VN222468 – Proposed Residential Development, Primrose Lane, Liversedge

Transport Assessment Addendum Note

PRIMROSE LANE	
PROPOSED SITE LAYOUT	
title: PRIMROSE LANE HIGHTOWN	
client: JONES HOMES	
client ref: 	Niemen Architects Desk 2, The Waterscape 42 Leeds & Bradford Road Kirkstall, Leeds, LS5 3EG T: 0113 239 5400 office@niemen.co.uk
date: 22/02/22	scale: 1:500@A1
drawing no: 3416-1-001	revision: DD

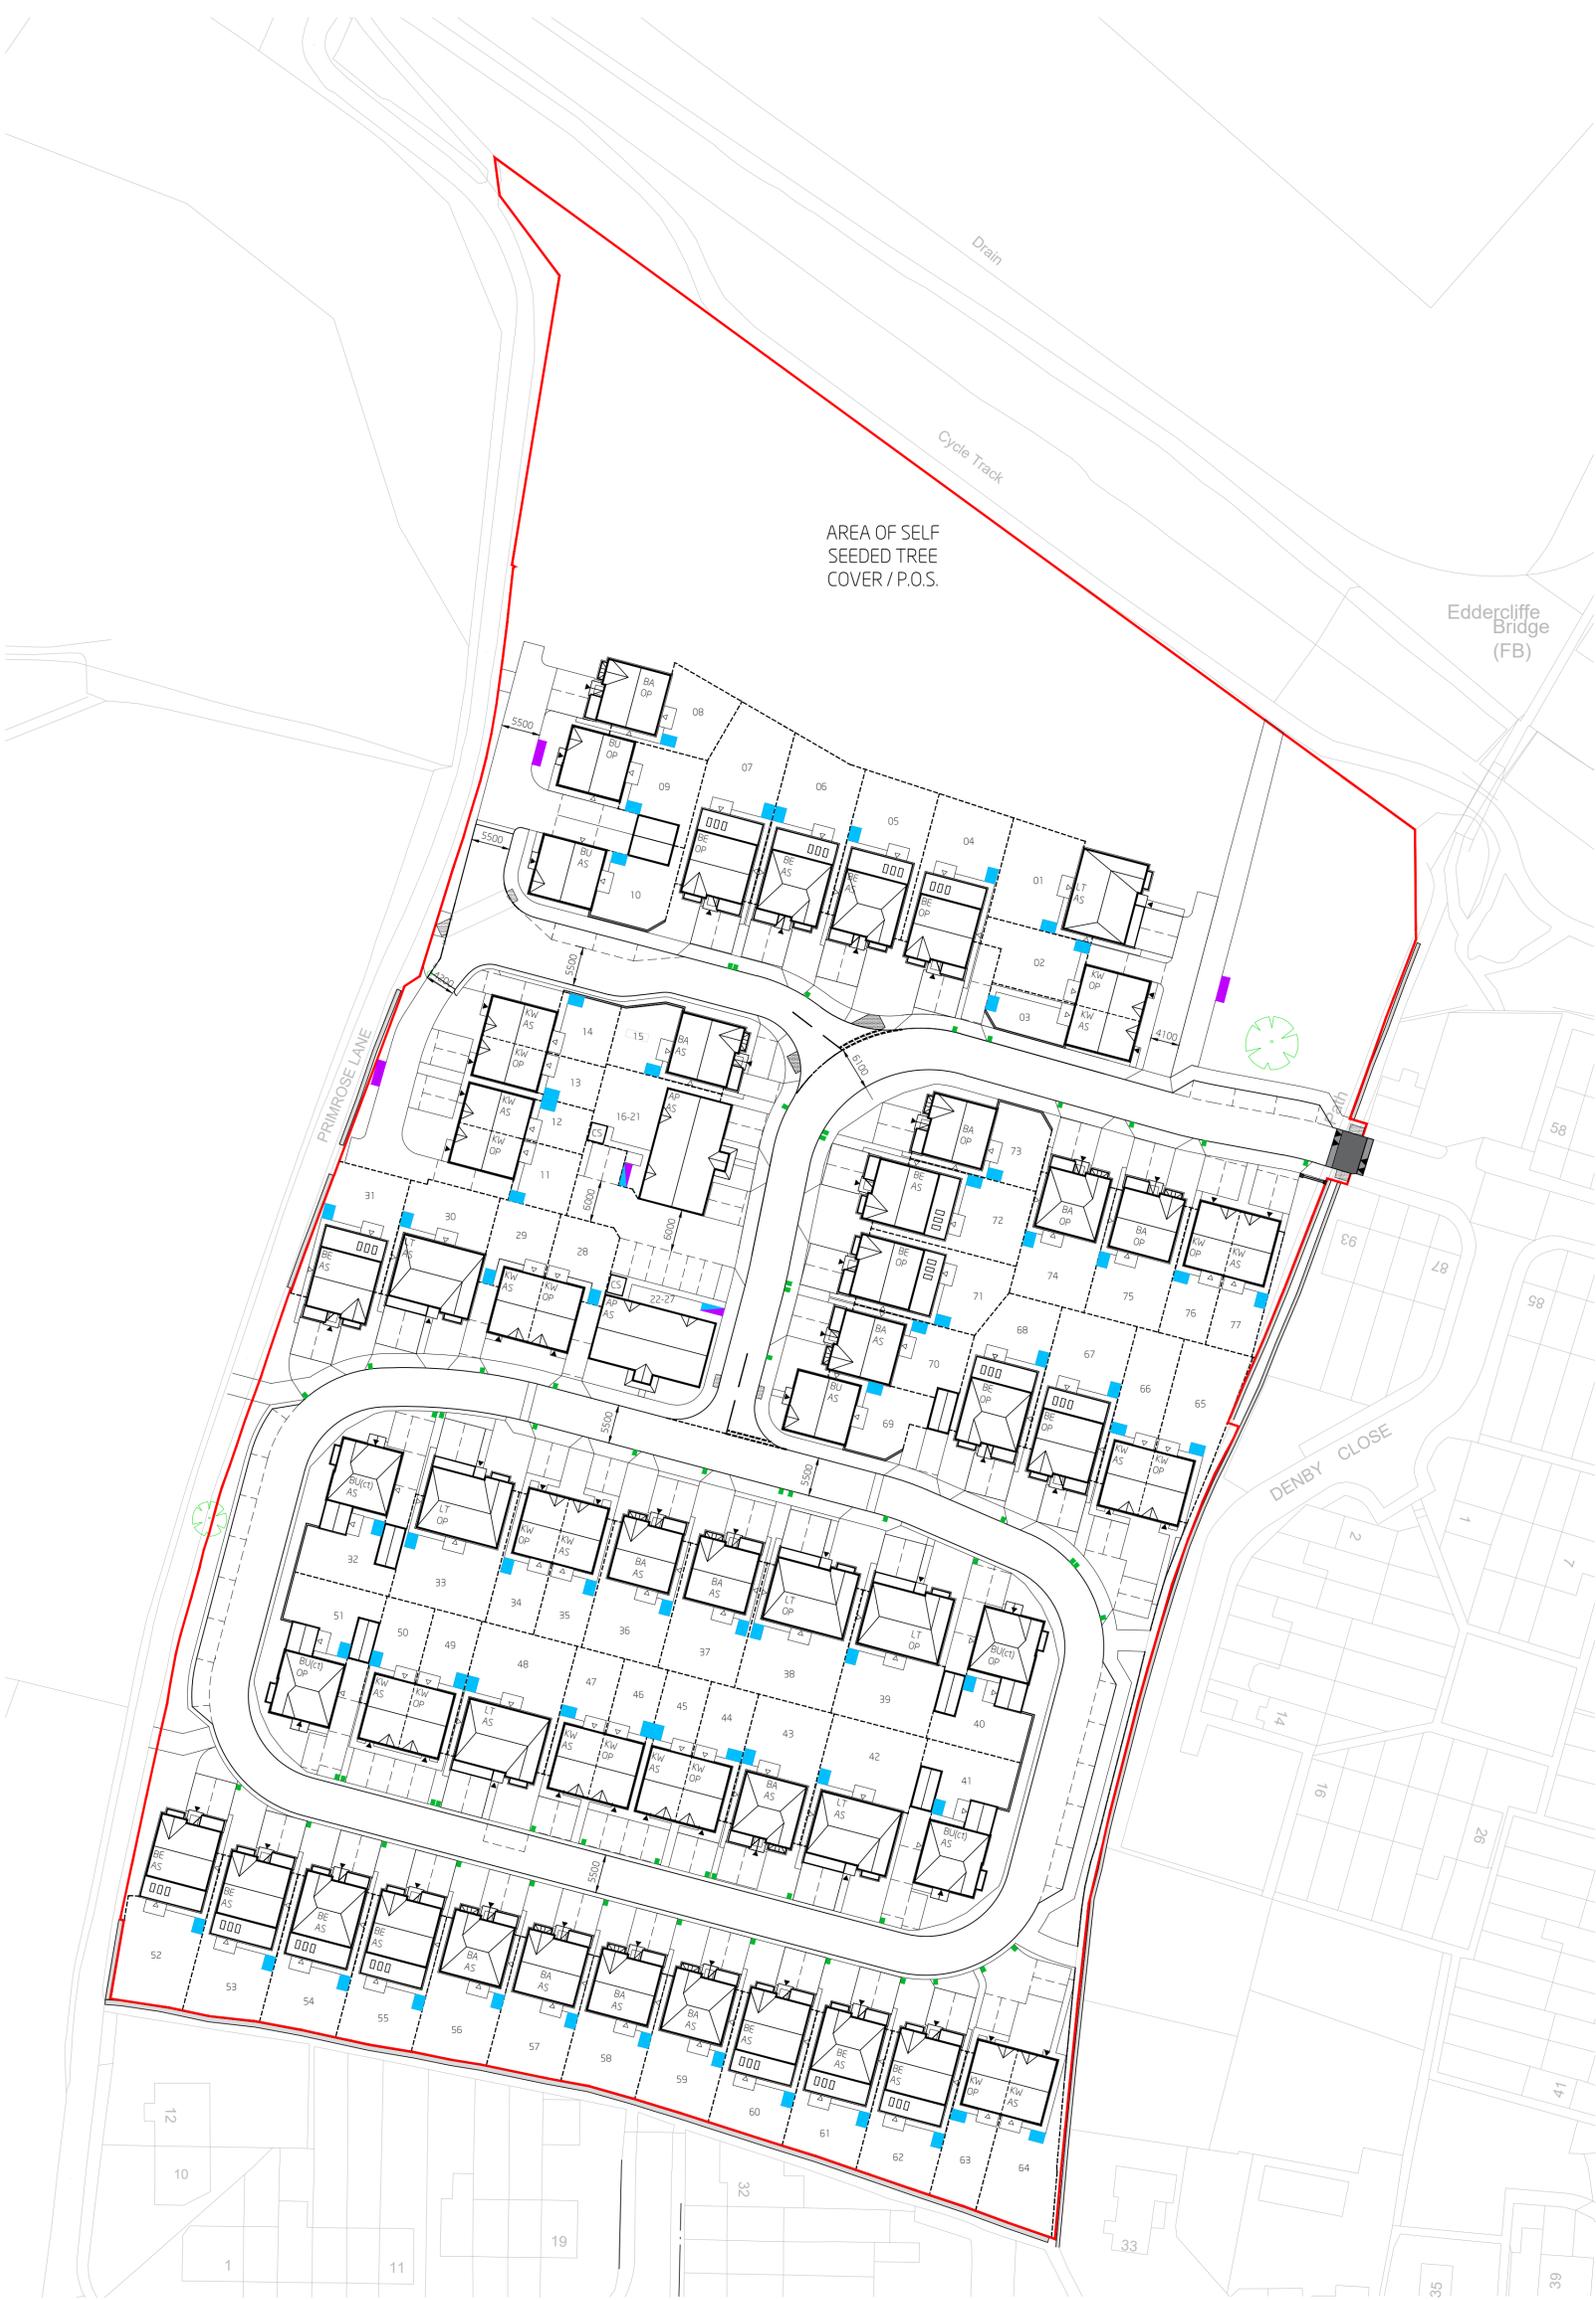
As identified at the pre-application stage, to gain access to the site it is necessary to cross public footpath PROW SPE/110/20 that runs along the full extent of the eastern site boundary. However, there appears to be no public vehicle rights over this footpath, and the land occupied by the PROW is not within the development site boundary and appears to be unregistered. Therefore, the applicant was advised to investigate the legalities of ownership and the available rights to convert these sections of PROW to dedicated all-purpose highway to serve the development. As such, it is understood that the applicant has sought advice from the Councils Highway Design and Public Rights of Way teams, to consider the mechanism that could be used to deliver the site access, which is confirmed in Section 5.5 of the Transport Assessment. It is understood that this matter is still be considered by relevant officers, and further comments will be provided to the applicant in due course.

A link to Spen Valley Greenway is proposed, as well as links to Bridleway SPE/111/120, which are welcome. However, the paths only appear to be 2m wide, which are inadequate for multi-use routes. Therefore, improvements are required to ensure that they comply with the requirements of LTN 1/20. This must also include information regarding the proposed surfacing and gradients of the routes, to ensure that they are suitable for all users. Links to footpath SPE/110/20 are proposed, which are also welcome. However, there are again no details of the width, surface treatment or gradients.

The drive for Plot 3 is located at a junction, which is not good practice and will prevent a suitable pedestrian crossing (with tactile paving) being provided at the junction. This drive should be relocated, and the plans should clearly demonstrate suitable pedestrian crossing points throughout the site.

The land occupied by public footpath PRoW SPE/110/20 at the location of the proposed vehicular access from Darley Road is included within the development site boundary, as shown on the revised site layout plan.

The proposed linkages to these active travel routes are designed as 3m wide multi-use routes, as shown on the revised site layout plan. The maximum gradient of these proposed linkages will be no steeper than around 1 in 12, in line with Inclusive Mobility (December 2021), which is the Department for Transport's best practice guidance. It is recommended that full details about surfacing can be conditioned as part of the detailed design process.

The proposed layout of this part of the site has been updated with changes to the driveway positions and the provision of a dropped kerb crossing at the junction, as shown on the revised site layout plan.

For the apartments, cycle stores will be provided for the two buildings to provide secure cycle storage for 12 bikes, and this is shown on the revised site layout plan. For the houses, secure cycle parking storage will be feasible within the curtilages of each dwelling and if desired, residents will be able to secure bicycles in rear gardens.
